# **Manual 03A, Rev. 19**

## **Energy Management System (EMS) Model Updates and Quality Assurance (QA)**

### **2020 Periodic Review**

Maria Baptiste, Sr. Business Analyst  
Model Management Department  
Operating Committee  
October 08, 2020

## Bulk Ratings Changes:

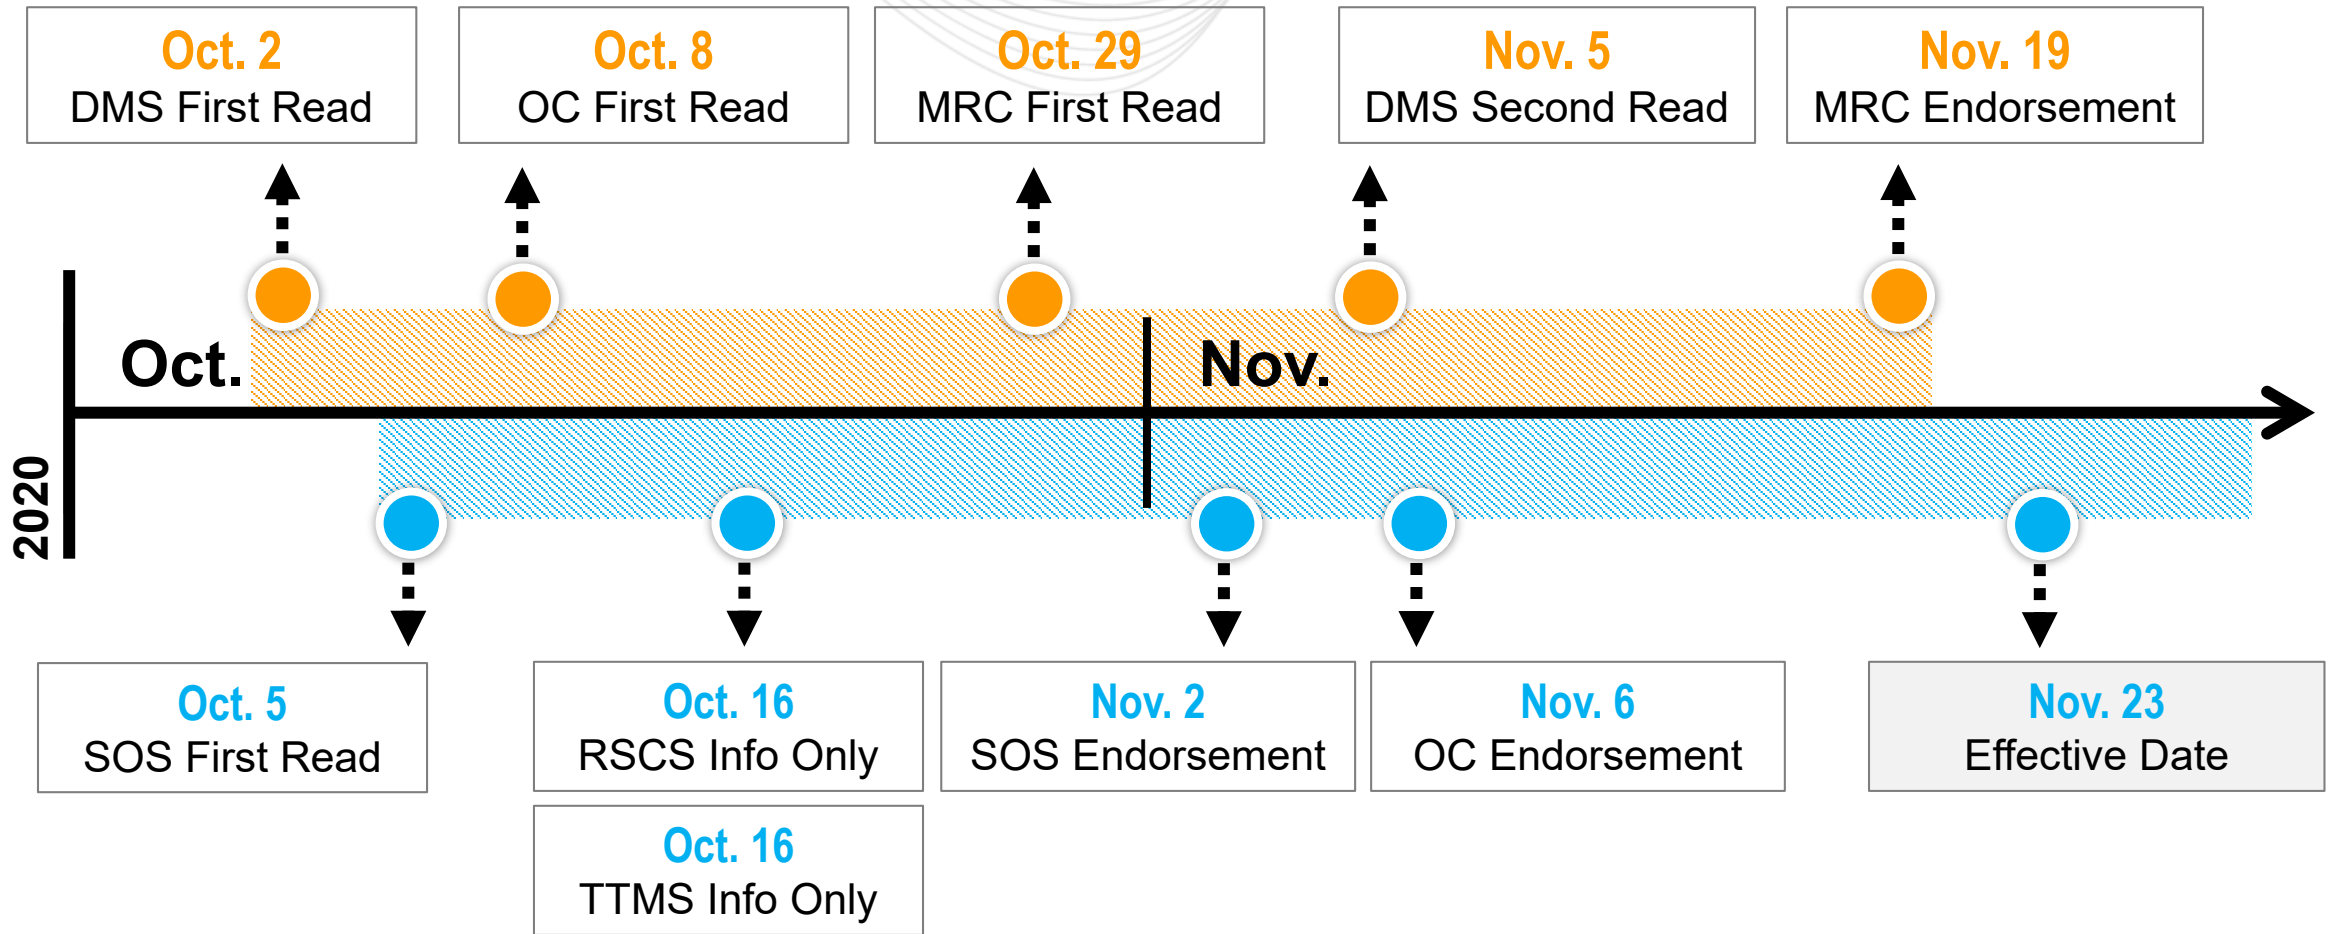
- Able to make changes outside of a scheduled model build
- Removed reference to Appendix C, Exhibit of MPs (unrelated to text)
